STAFF REPORT
(One-Step Final Plat)

CASE NUMBER: SUB 2001-120 – BENCOR 3rd ADDITION

LOCATION: Northwest corner of Harry and Broadway

VICINITY MAP

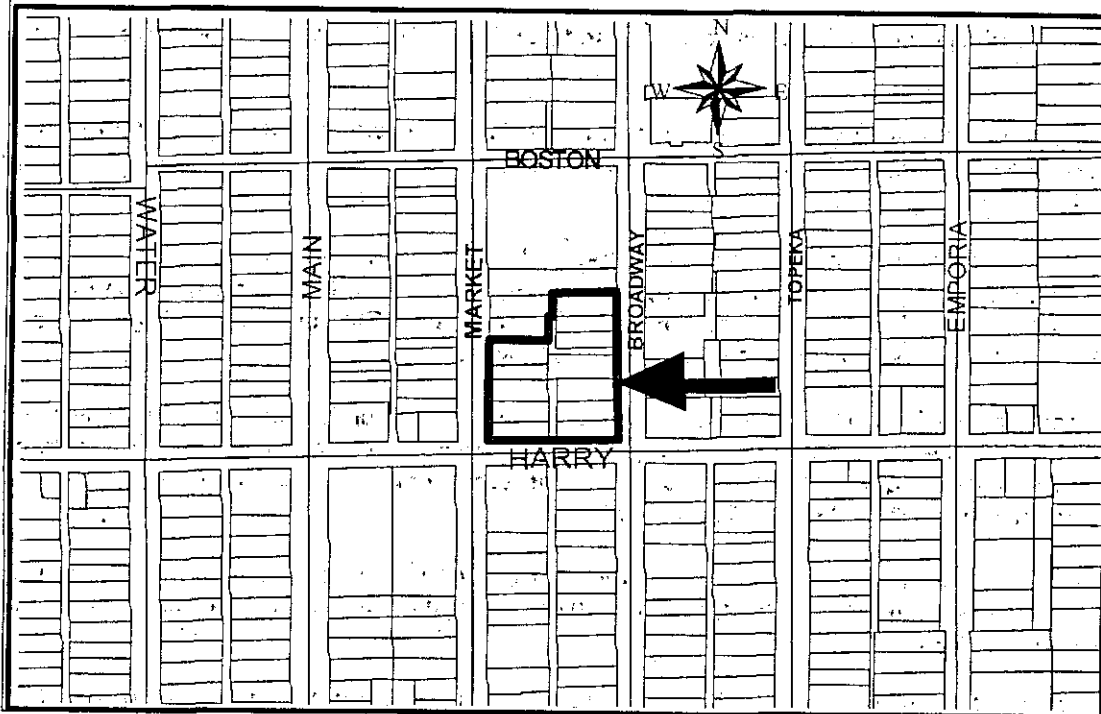
- C. City Engineering needs to comment on the status of the applicant's drainage plan.
- D. Traffic Engineering has required a distance of 75 feet from the inside of curb along Market to the inside of the curb for the proposed opening along Harry. The plat proposes one access opening along Market, one opening along Harry and two openings along Broadway. The final plat shall reference the dedication of access controls in the plat's text.

- F. In accordance with the zone change approval, the applicant shall provide a cross-lot access agreement between the two lots.
- G. Traffic Engineering needs to comment on the proposed right-of-way for Market, which is classified as an arterial on the 2030 Transportation Plan. The applicant has decreased the existing 40-ft right-of-way to 35 feet. The Subdivision Regulations require a 50-ft half street right-of-way width for arterials.

- H. The 20-ft building setback needs to be platted parallel with the southeastern corner of the plat.
- I. The Applicant is reminded that a platting binder is required with the final plat. Approval of this plat will be subject to submittal of this binder and any relevant conditions found by such a review.
